**FINAL DRAINAGE REPORT
FOR
FOREST LAKES FILING 6
EL PASO COUNTY, COLORADO**

September 2020

SF-20-027

DP-9B INLET

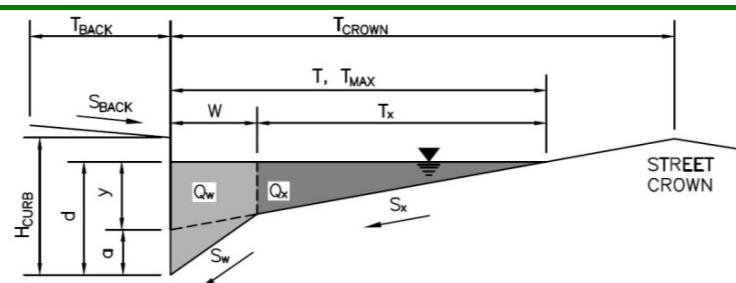
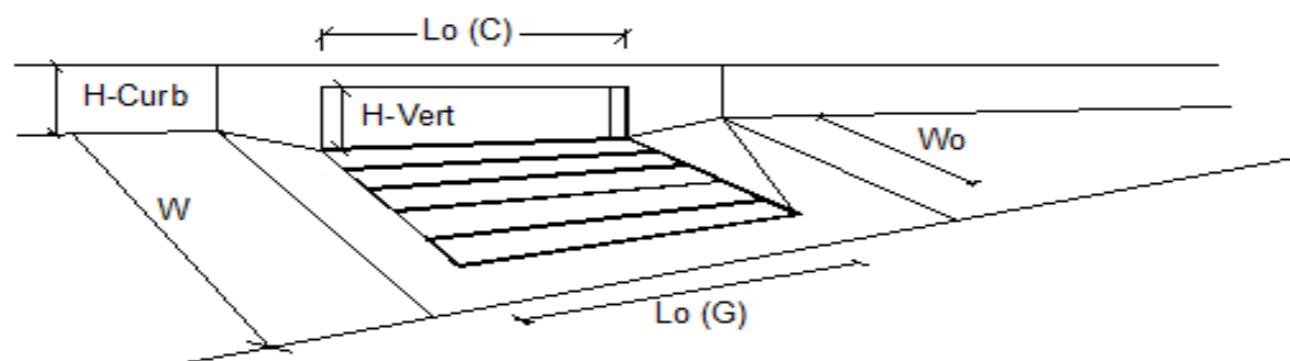
Provide a narrative description of Design Point 9B

DEVELOPED CONDITIONS DRAINAGE MAP

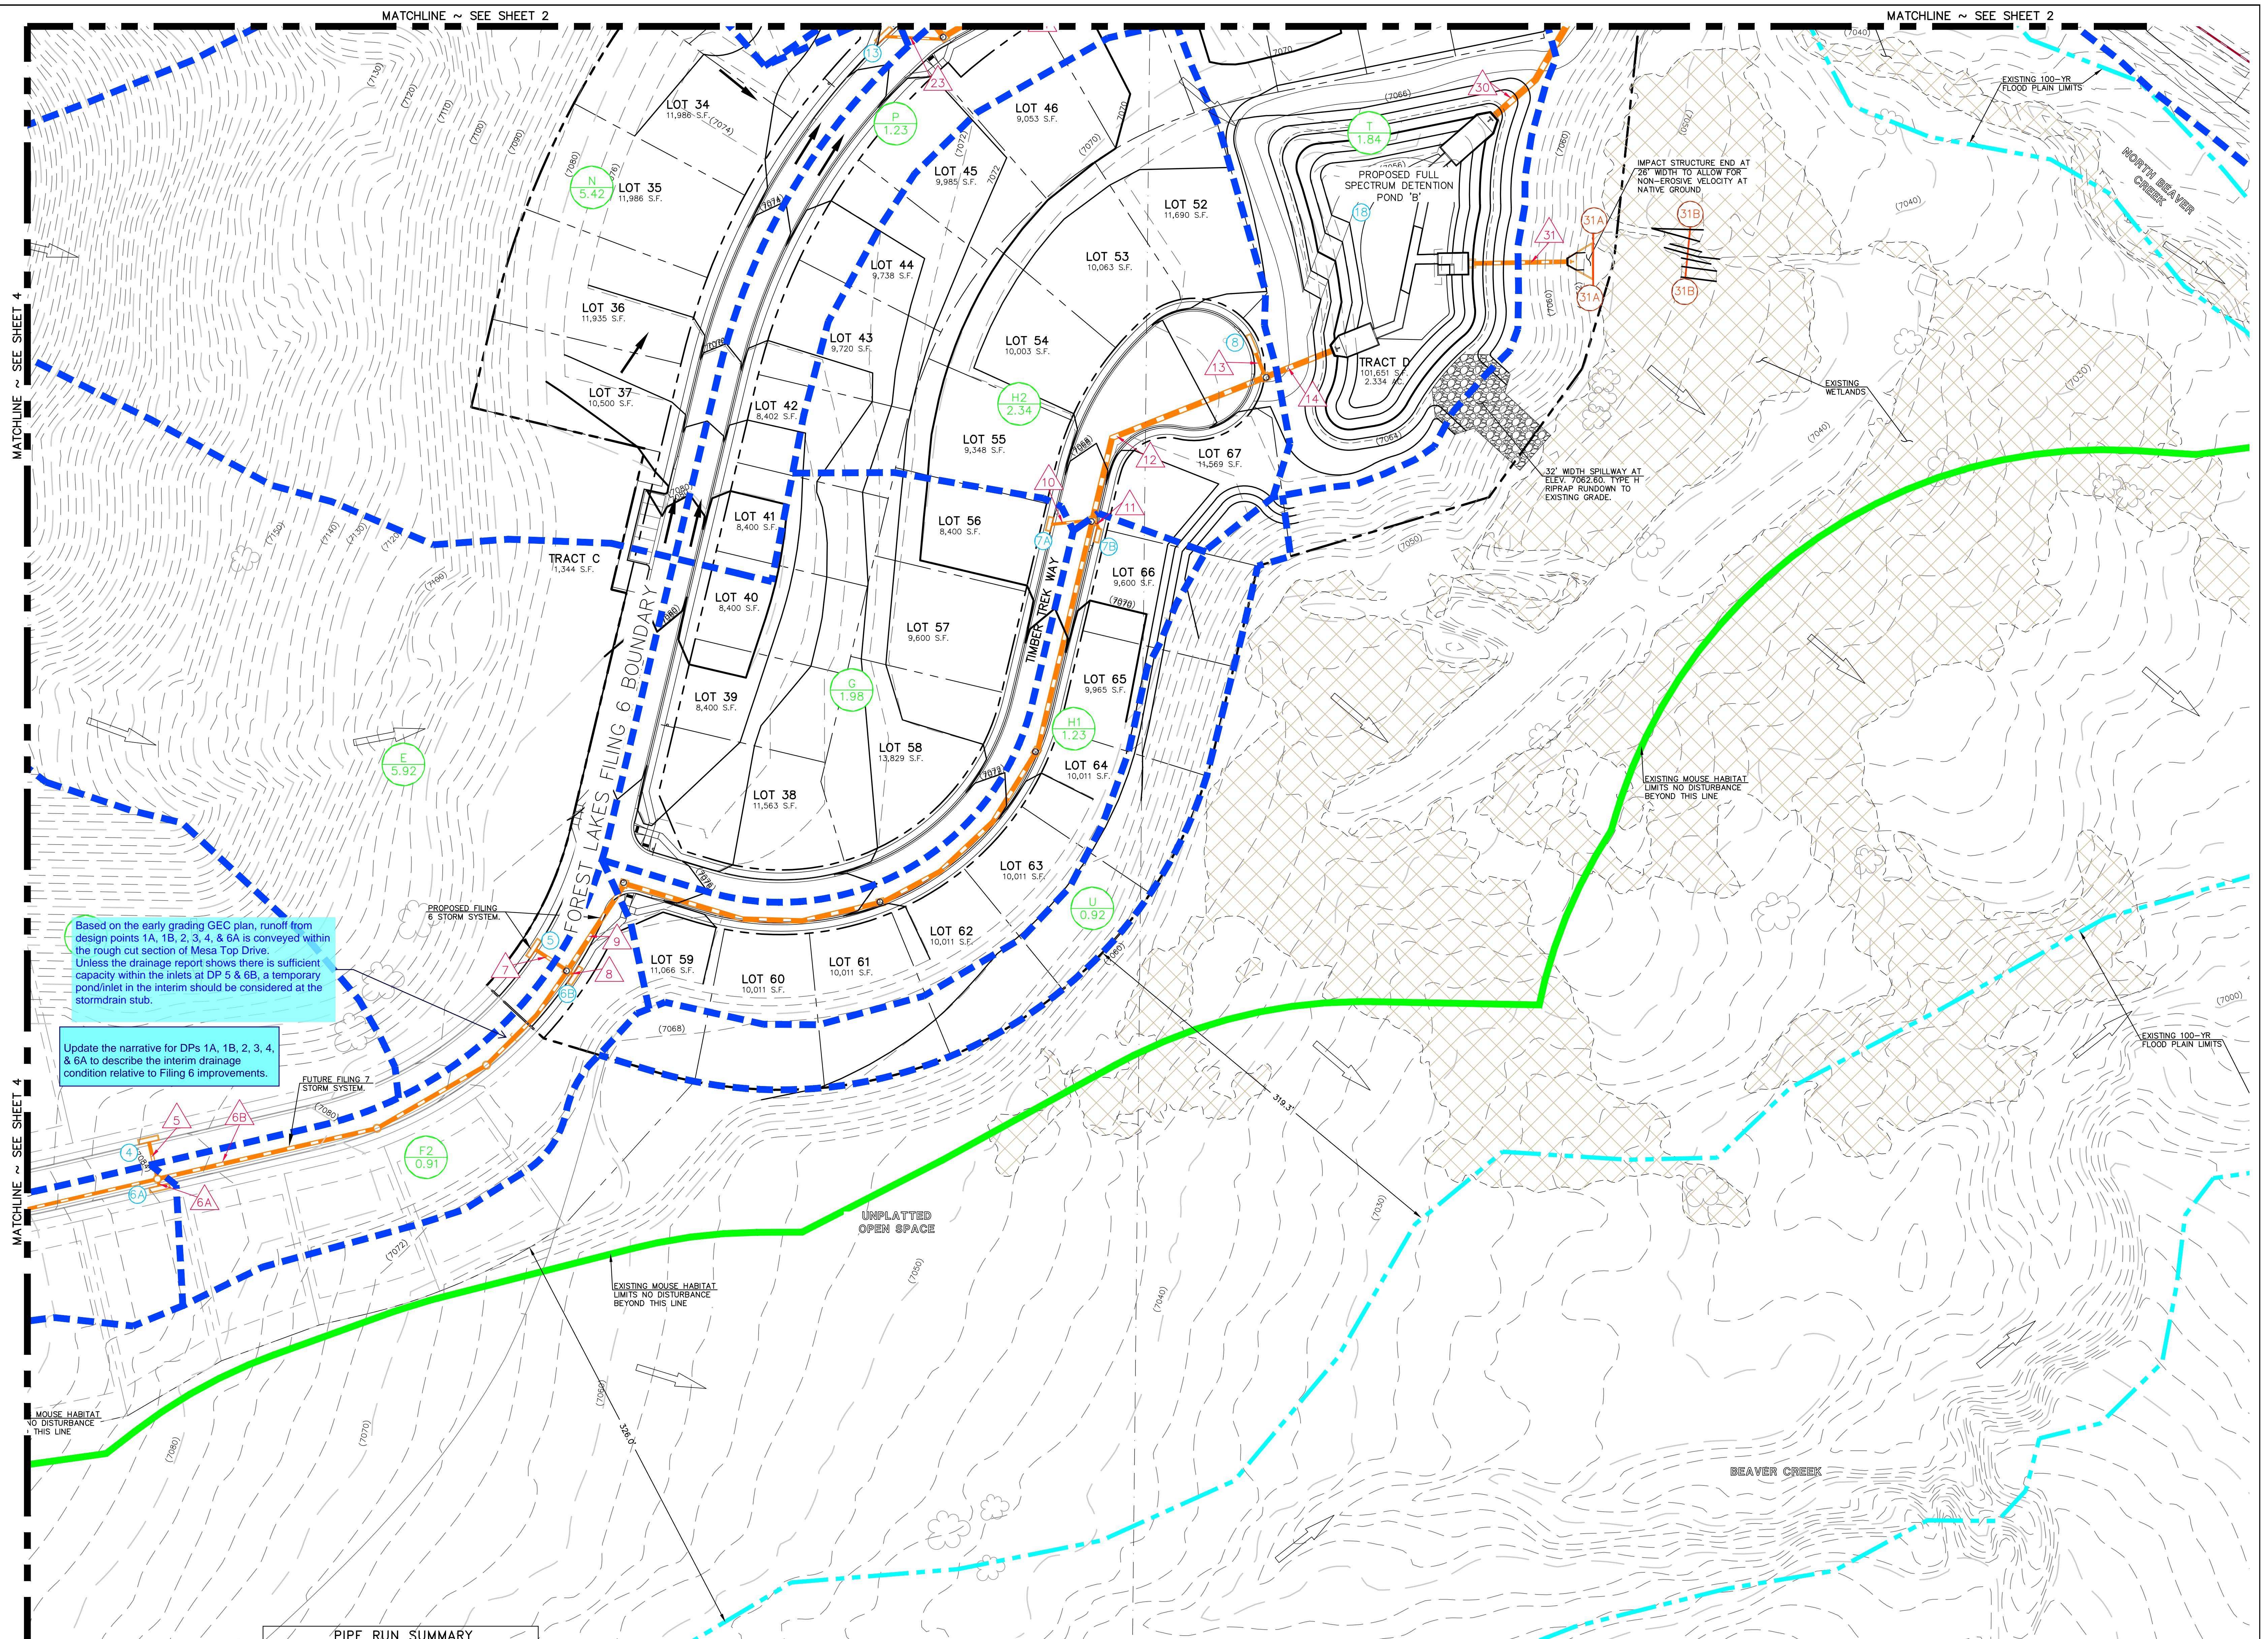
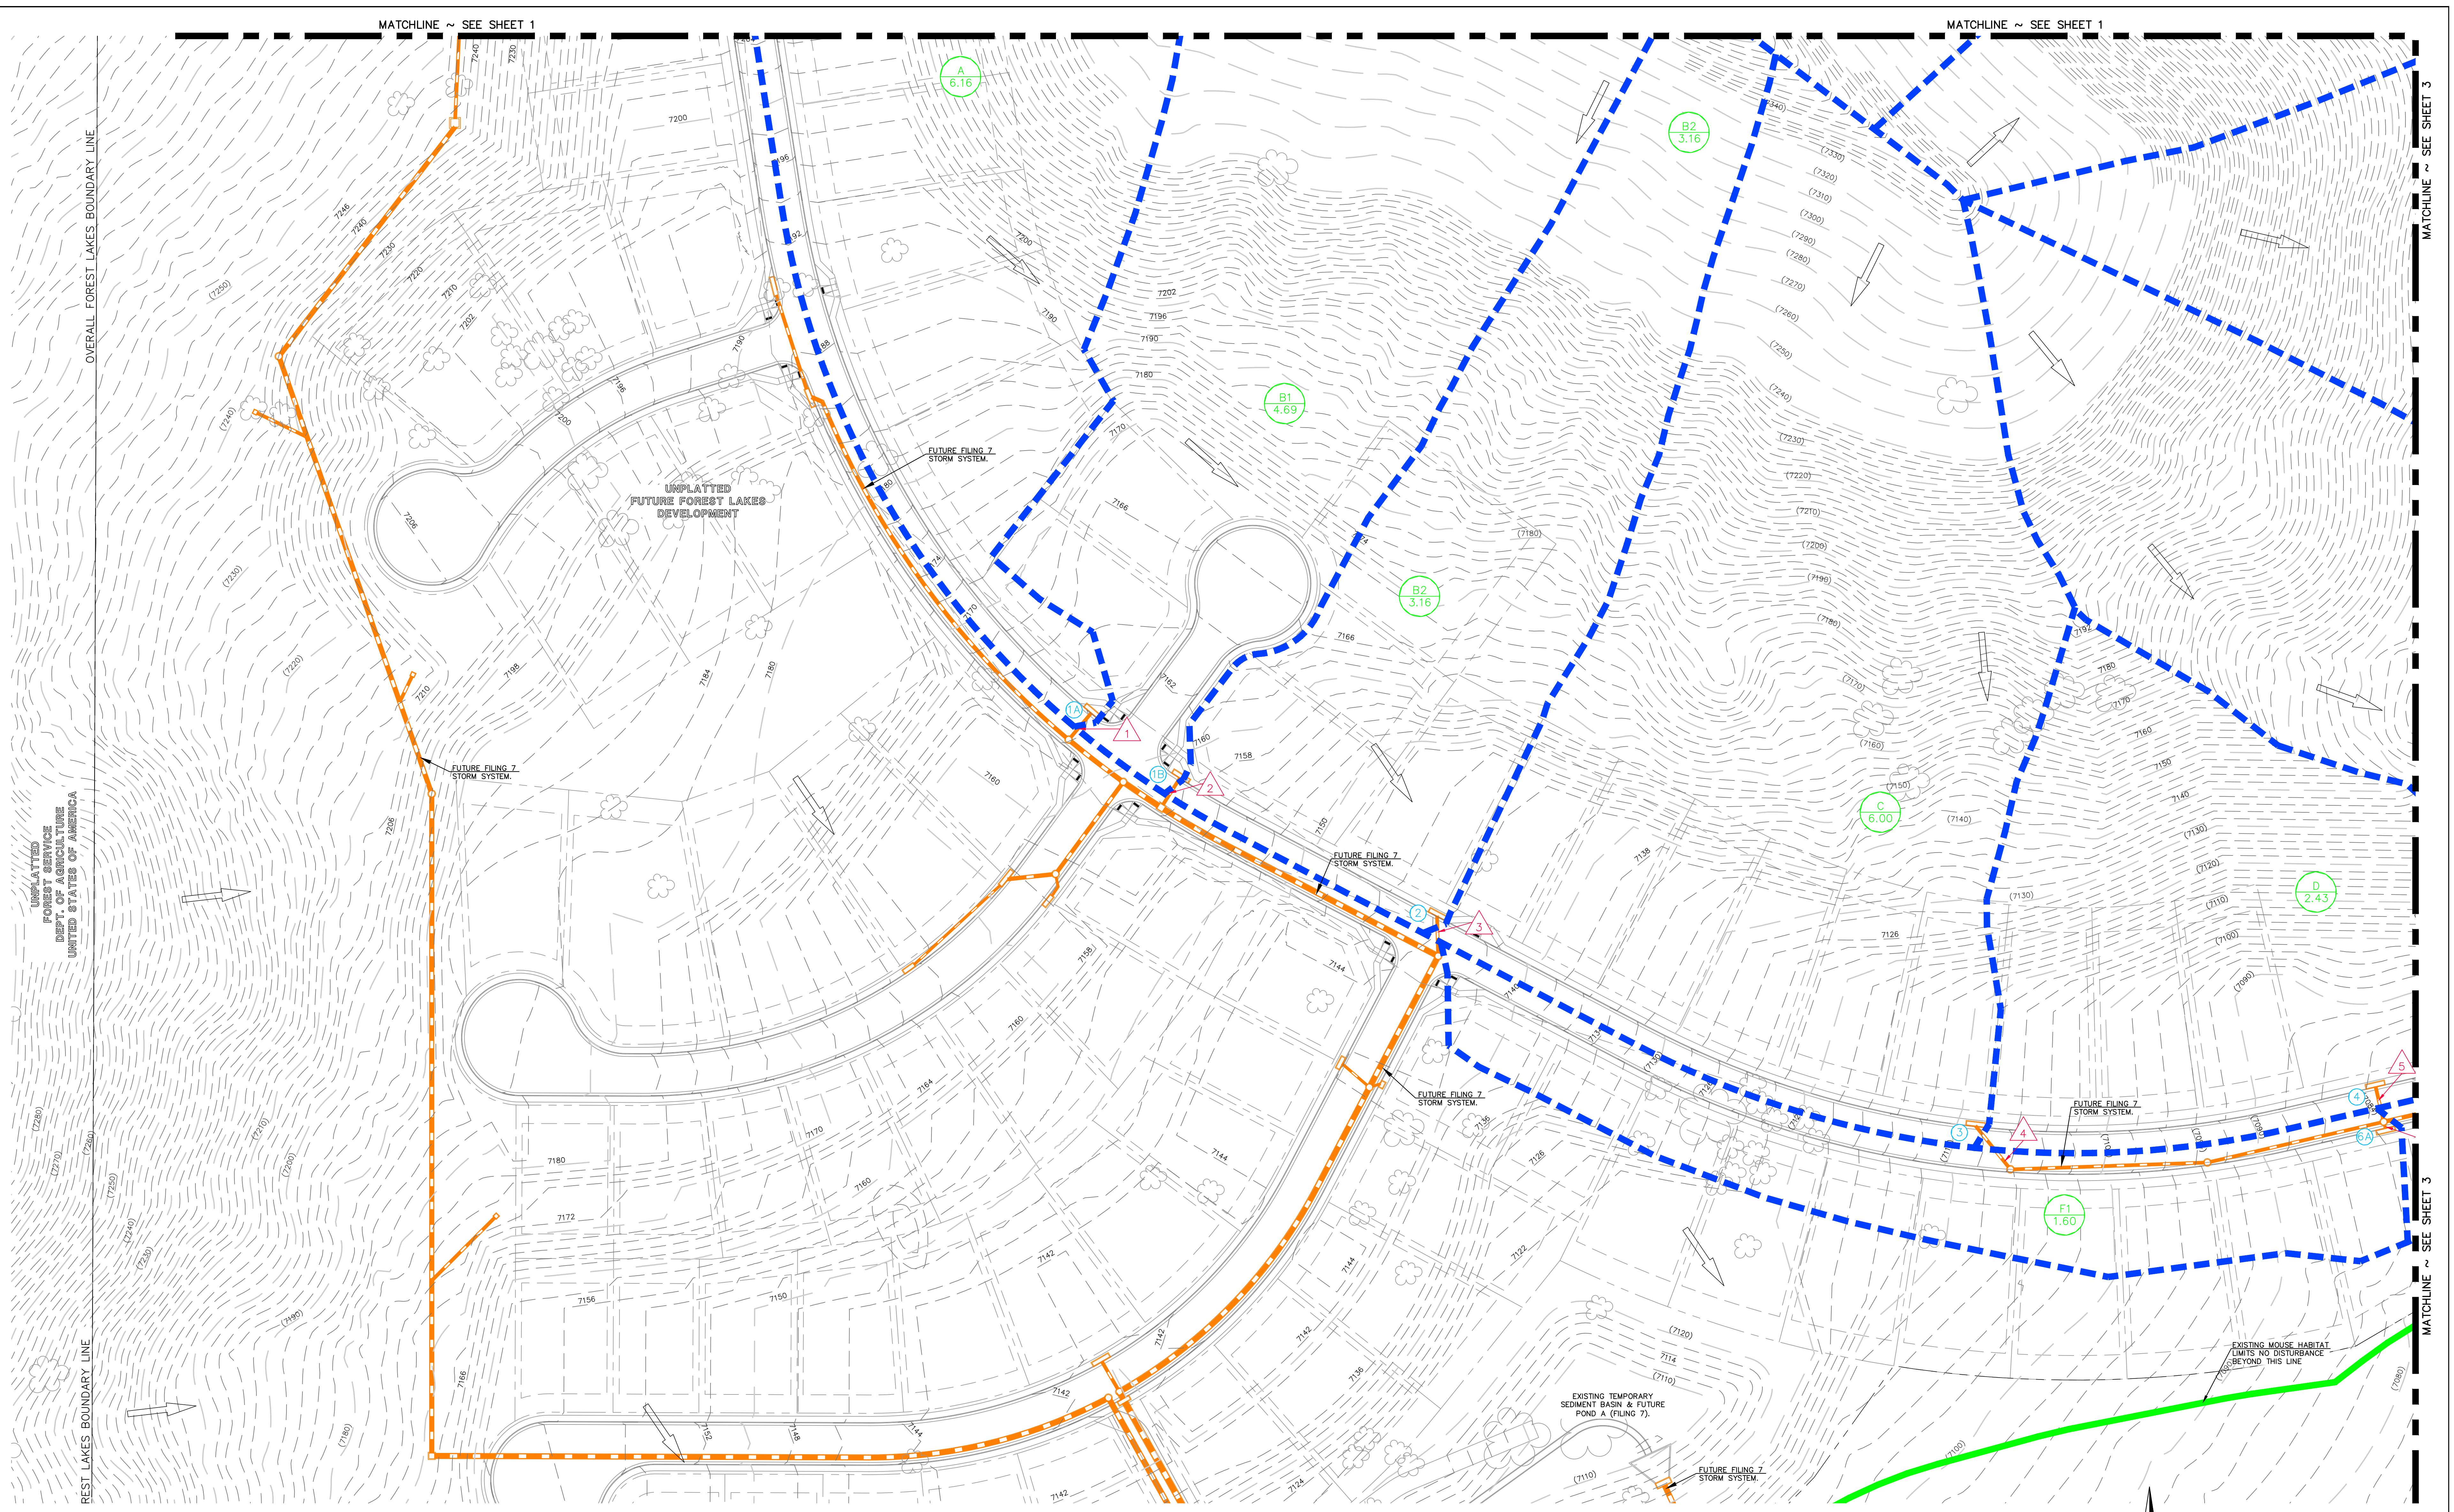
Revise to add this line style to legend.

Based on the early grading GEC plan, runoff from design points 1A, 1B, 2, 3, 4, & 6A is conveyed within the rough cut section of Mesa Top Drive. Unless the drainage report shows there is sufficient capacity within the inlets at DP 5 & 6B, a temporary pond/inlet in the interim should be considered at the stormdrain stub.
